STAFF LEVEL PROJECT REVIEW

DR Number: DR07-0266
Address: 3940 14th Street
APN: 020-0073-028
Description: Small Subdivision

STAFF ACTION AND CONDITIONS OF APPROVAL:

Exhibit C – Plan A Floor Plan

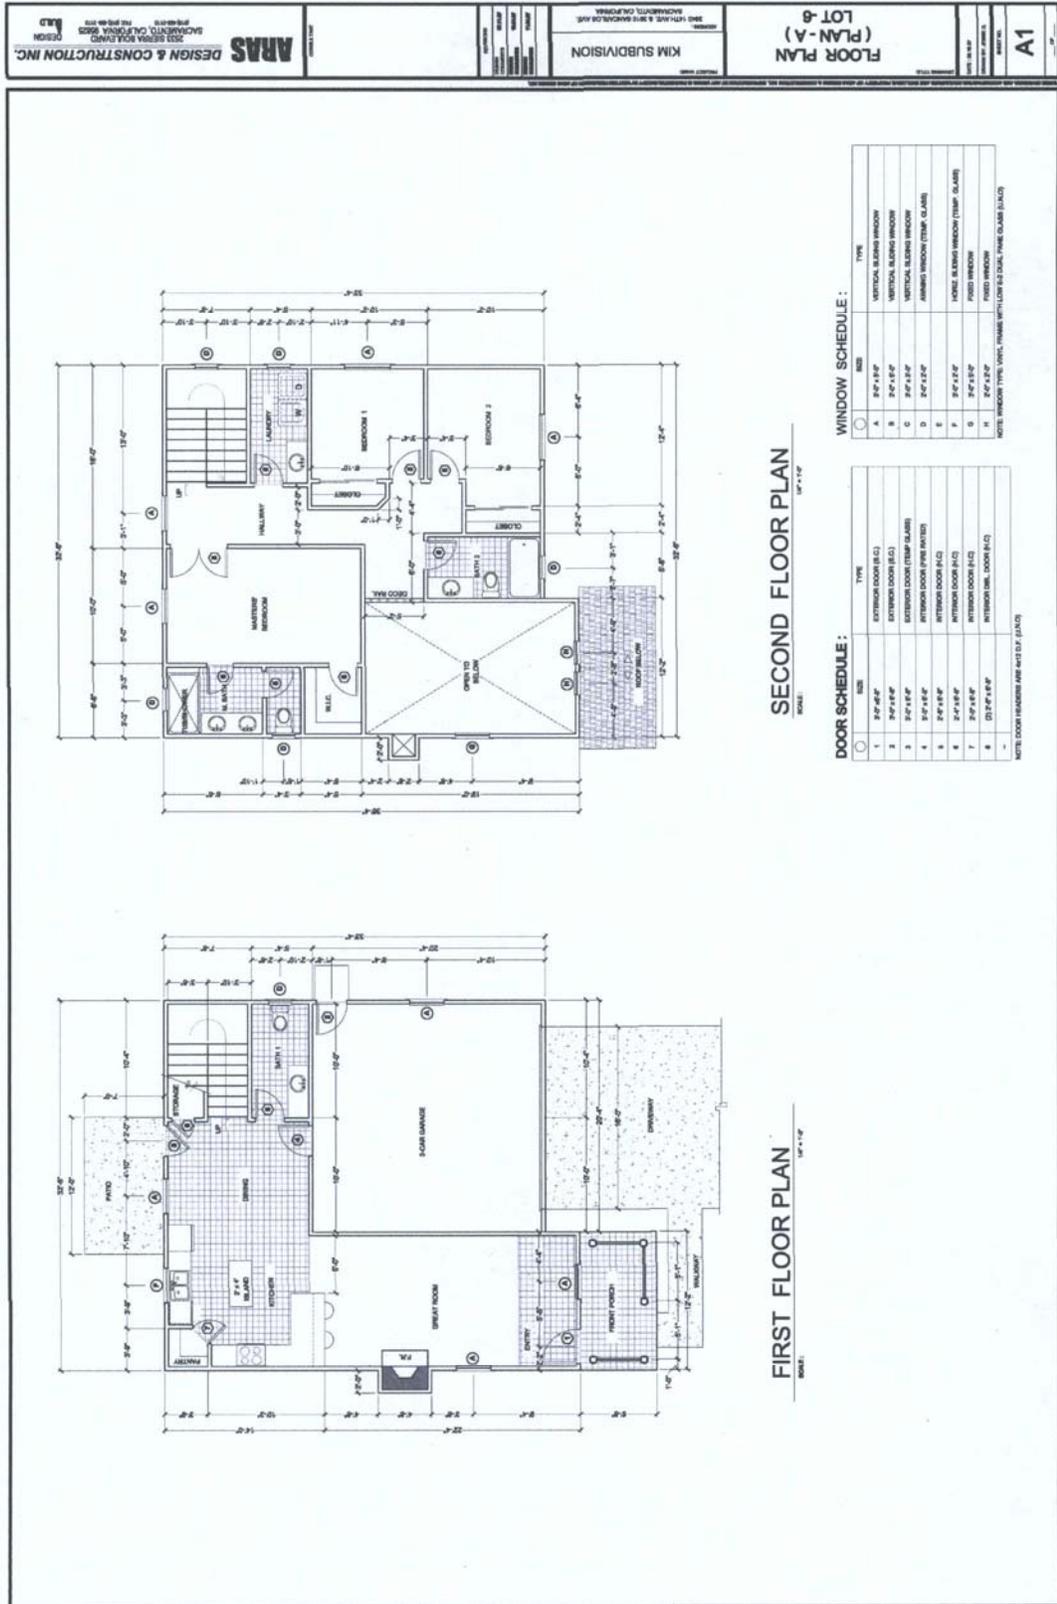
Conditions for Floorplan A, Lot 6:

1. New roof pitch (5 in 12) shall be provided per approved plans. A minimum 30-year laminated dimensional composition shingle shall be provided per approved plans.

2. New 6-inch exposure wood or fiber cement horizontal lap siding shall be provided on all elevations per approved plans. All lap siding shall be smooth finish, no stamped grain.

3. Gable roof at front elevation shall be provided per approved plans. New board and batten (wood or fiber cement) vertical siding at front elevation gables shall be provided per approved plans.

4. Horizontal 18" wood trim board shall be provided on all elevations per approved plans.
5. Wide frame vinyl windows with decorative wood (1" X 4") trim, projecting wood sills and aprons shall be provided per approved plans. Grids shall be provided on all elevation windows per approved plans.

6. Window shutters shall be provided at front elevation windows per approved plans.
7. Front porch shall be provided per approved plans. New decorative wood front porch columns with 18" built-out wood bases shall be provided per approved plans. New top mounded wood guardrail and bottom rail with 2" X 2" wood pickets at 4" centers, shall be provided at front porch per approved plans.

8. New chimney with 6-inch exposure wood or fiber cement horizontal lap siding shall be provided per approved plans.
9. Gable vents with wood louvers and 1" X 2" decorative trim shall be provided per approved plans.

10. Front entry door with raised panel design shall be provided per approved plans.
11. Raised panel garage door with top window row shall be provided per approved plans.

12. Provide painted gutters and downspouts per redlined drawings.
13. Provide decorative light fixtures at front and rear doors, and garage door per approved plans.

Exhibit E – Plan B Floor Plan

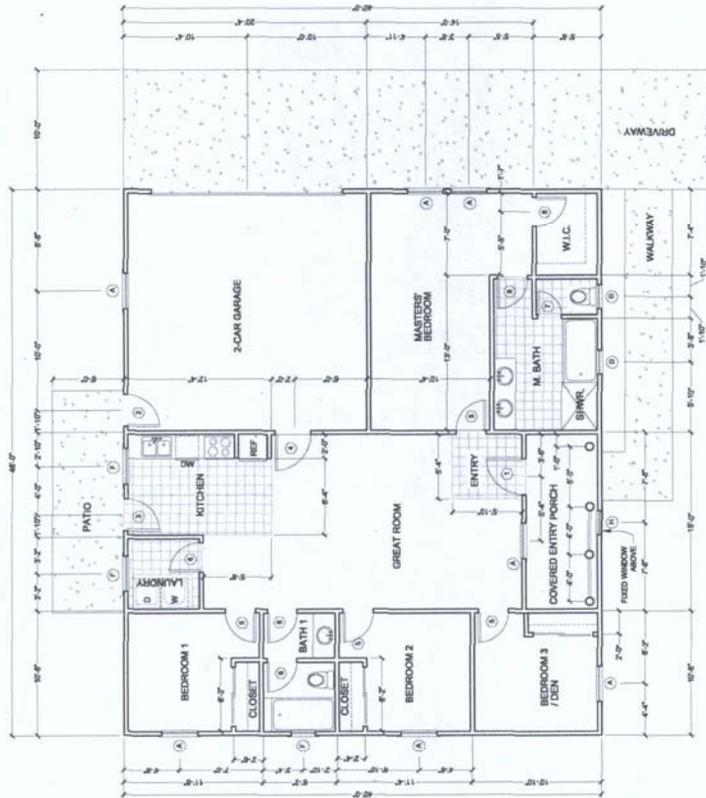
Conditions for Floorplan B, Lot 4:

14. New roof pitch (5 in 12) shall be provided per approved plans. A minimum 30-year laminated dimensional composition shingle shall be provided per approved plans.

15. New 6-inch exposure wood or fiber cement horizontal lap siding shall be provided on all elevations per approved plans. All lap siding shall be smooth finish, no stamped grain.

16. Wide frame vinyl windows with decorative wood (1" X 4") trim, projecting wood sills and aprons shall be provided per approved plans. Grids shall be provided on all elevation windows per approved plans.

17. Window shutters shall be provided at front elevation windows per approved plans.
18. Front porch shall be provided per approved plans. New decorative wood front porch columns with 18" built-out wood bases shall be provided per approved plans. New top mounded wood guardrail and bottom rail with 2" X 2" wood pickets at 4" centers, shall be provided at front porch per approved plans.

19. Front entry door with raised panel design shall be provided per approved plans.
20. Raised panel garage door with top window row shall be provided per approved plans.

21. Provide painted gutters and downspouts per redlined drawings.
22. Provide decorative light fixtures at front and rear doors and garage door per approved plans.

Exhibit G – Plan C Floor Plan

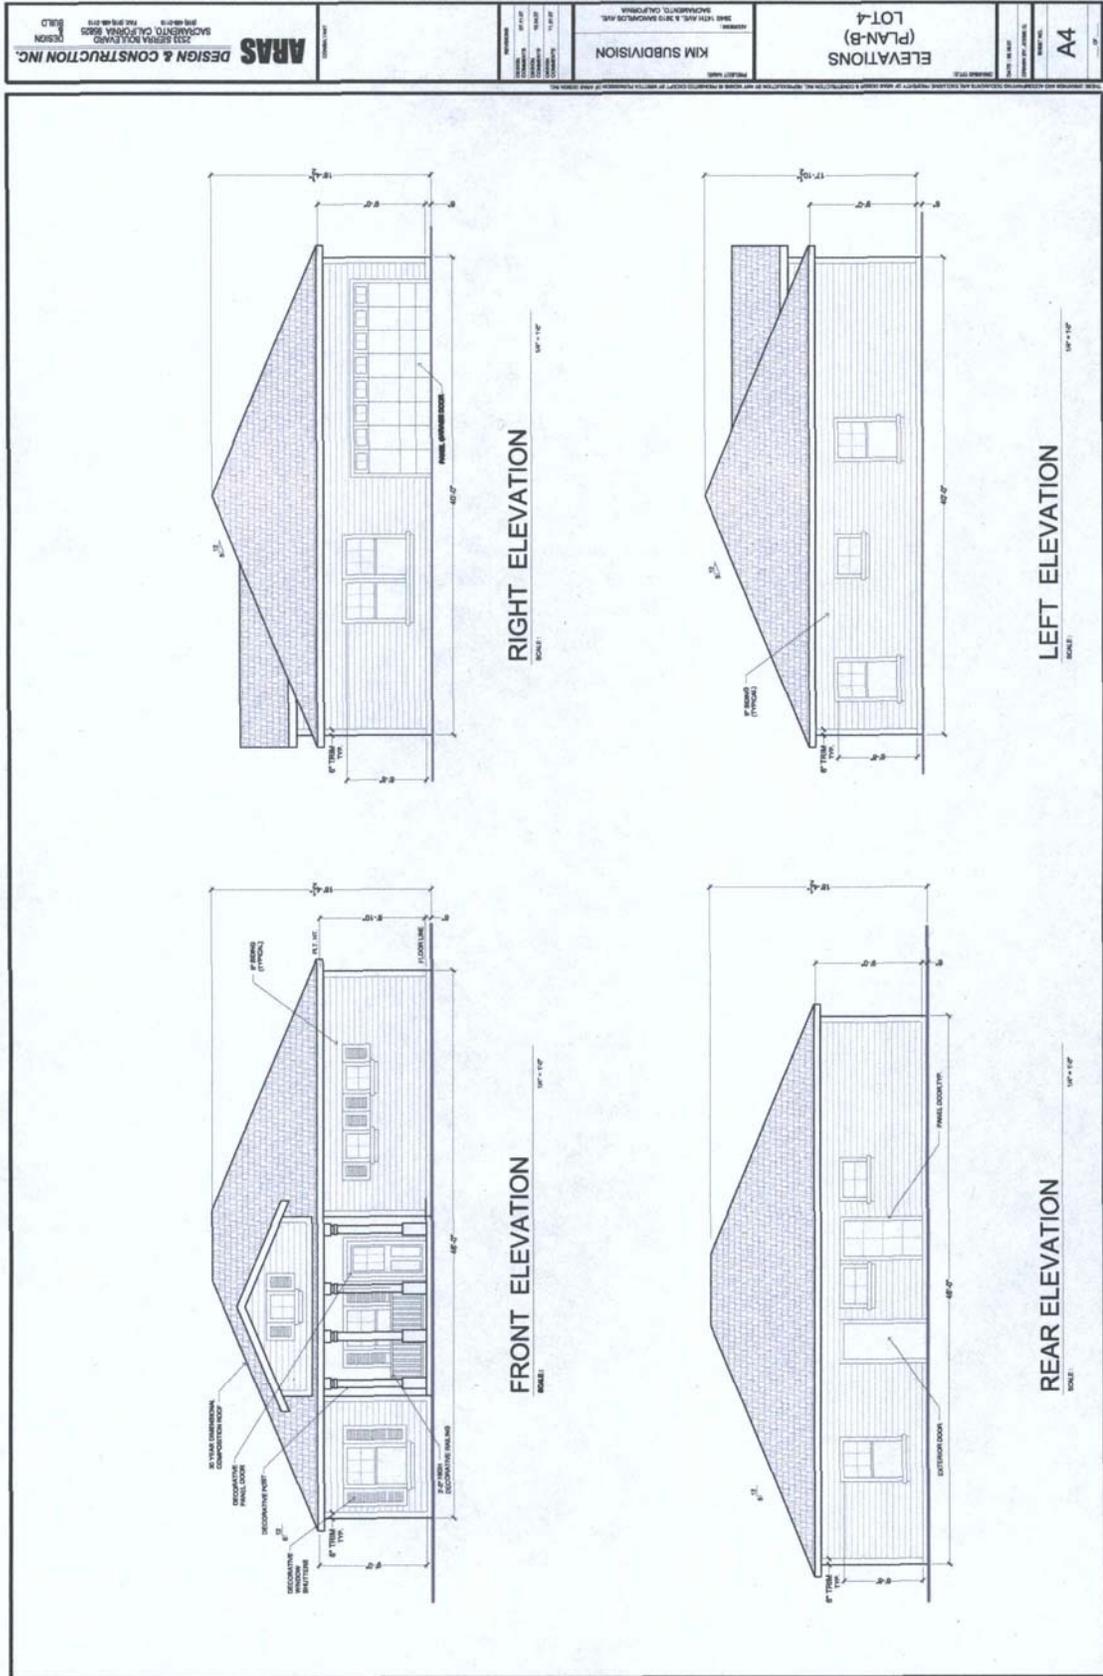
Conditions for Floorplan C, Lot 5:

23. New roof pitch (5 in 12) shall be provided per approved plans. A minimum 30-year laminated dimensional composition shingle shall be provided per approved plans.

24. New 6-inch exposure wood or fiber cement horizontal lap siding shall be provided on all elevations per approved plans. All lap siding shall be smooth finish, no stamped grain.

25. New board and batten (wood or fiber cement) vertical siding at front and rear elevation gables shall be provided per approved plans.
26. Horizontal 18" trim board shall be provided on all elevations per approved plans.

27. Wide frame vinyl windows with decorative wood (1" X 4") trim, projecting wood sills and aprons shall be provided per approved plans. Grids shall be provided on all elevation windows per approved plans.

28. Window shutters shall be provided at front elevation windows per approved plans.
29. Front porch shall be provided per approved plans. New decorative wood front porch columns with 18" built-out wood bases shall be provided per approved plans. New top mounded wood guardrail and bottom rail with 2" X 2" wood pickets at 4" centers, shall be provided at front porch per approved plans.

30. New chimney with 6-inch exposure wood or fiber cement horizontal lap siding shall be provided per approved plans.
31. Gable vents with wood louvers and 1" X 2" decorative trim shall be provided per approved plans.

32. Front entry door with raised panel design shall be provided per approved plans.
33. Raised panel garage door with top window row shall be provided per approved plans.

34. Provide painted gutters and downspouts per redlined drawings.
35. Provide decorative light fixtures at front, rear door, garage man-door and garage door per approved plans.

Exhibit I – Plan E Floor Plan

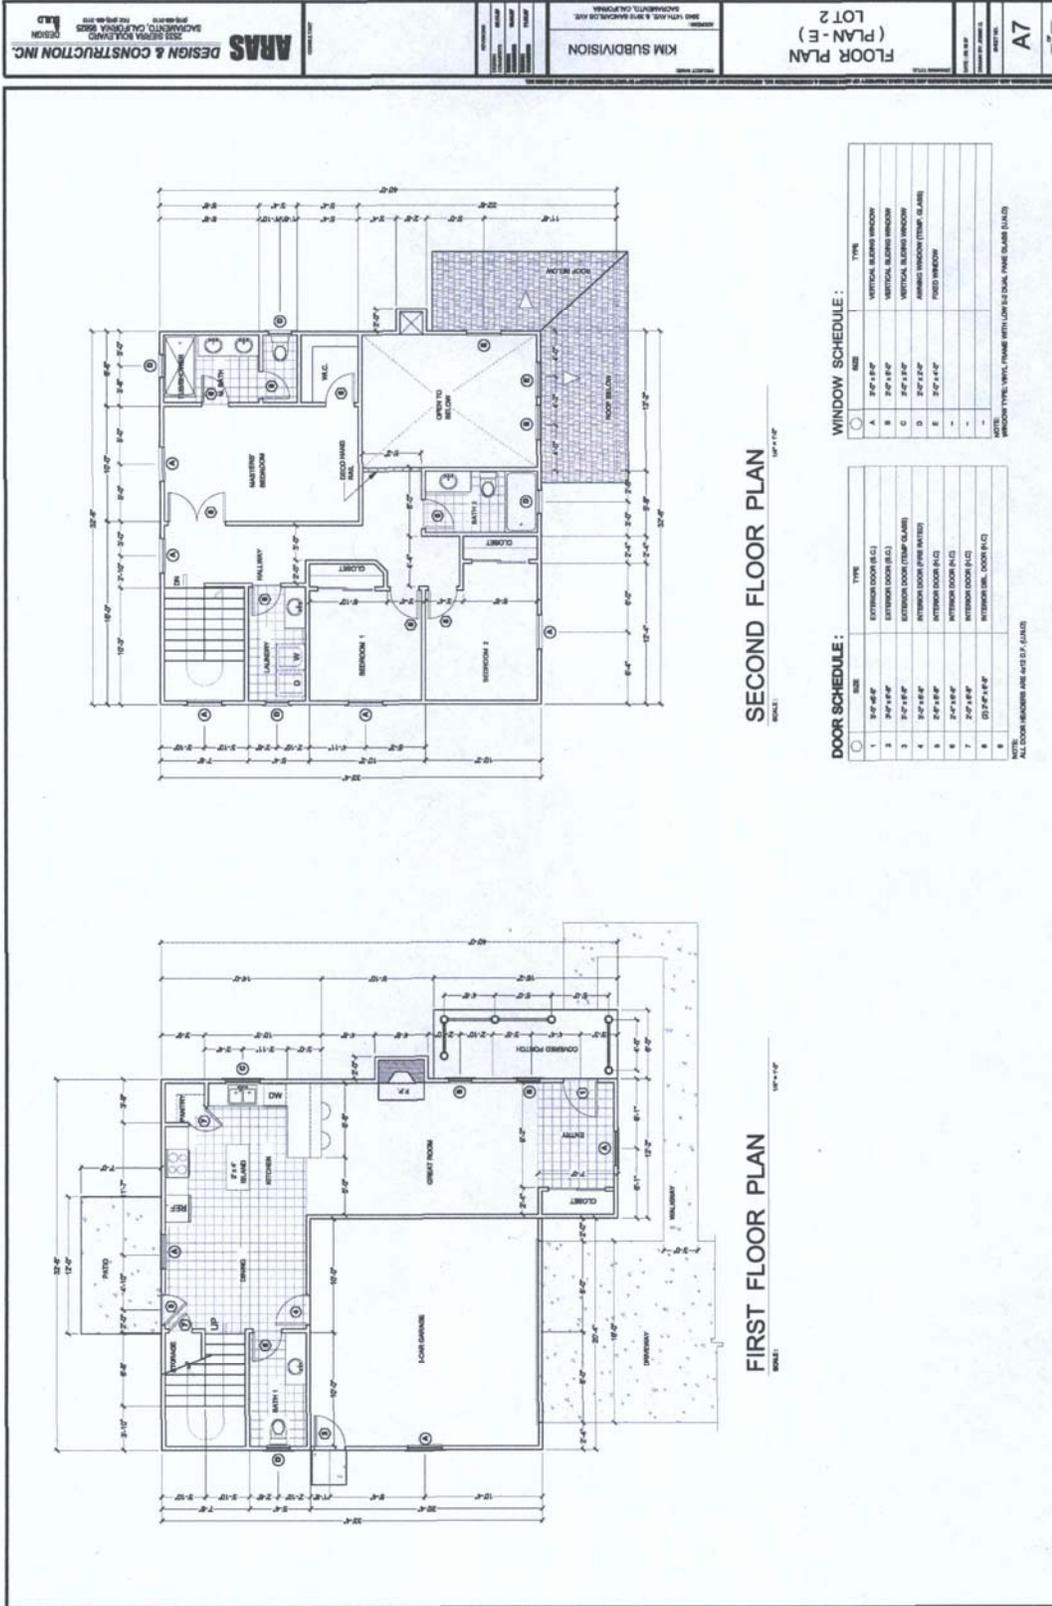
Conditions for Floorplan E, Lot 2:

36. New roof pitch (5 in 12) shall be provided per approved plans. A minimum 30-year laminated dimensional composition shingle shall be provided per approved plans.

37. New 6-inch exposure wood or fiber cement horizontal lap siding shall be provided on all elevations per approved plans. All lap siding shall be smooth finish, no stamped grain.

38. Horizontal 18" wood trim board shall be provided on all elevations per approved plans.
39. Wide frame vinyl windows with decorative wood (1" X 4") trim, projecting wood sills and aprons shall be provided per approved plans. Grids shall be provided on all elevation windows per approved plans.

40. Window shutters shall be provided at front and left elevation windows per approved plans.
41. Front porch shall be provided per approved plans. New flared out decorative wood columns with 36" built-out wood bases shall be provided per approved plans. New top mounded wood guardrail and bottom rail with 2" X 2" wood pickets at 4" centers, shall be provided at front porch per approved plans.

42. New chimney with 6-inch exposure wood or fiber cement horizontal lap siding shall be provided per approved plans.
43. Front entry door with raised panel design shall be provided per approved plans.

44. Raised panel garage door with top window row shall be provided per approved plans.
45. Provide painted gutters and downspouts per redlined drawings.

46. Provide decorative light fixtures at front, rear and side doors, and garage door per approved plans.
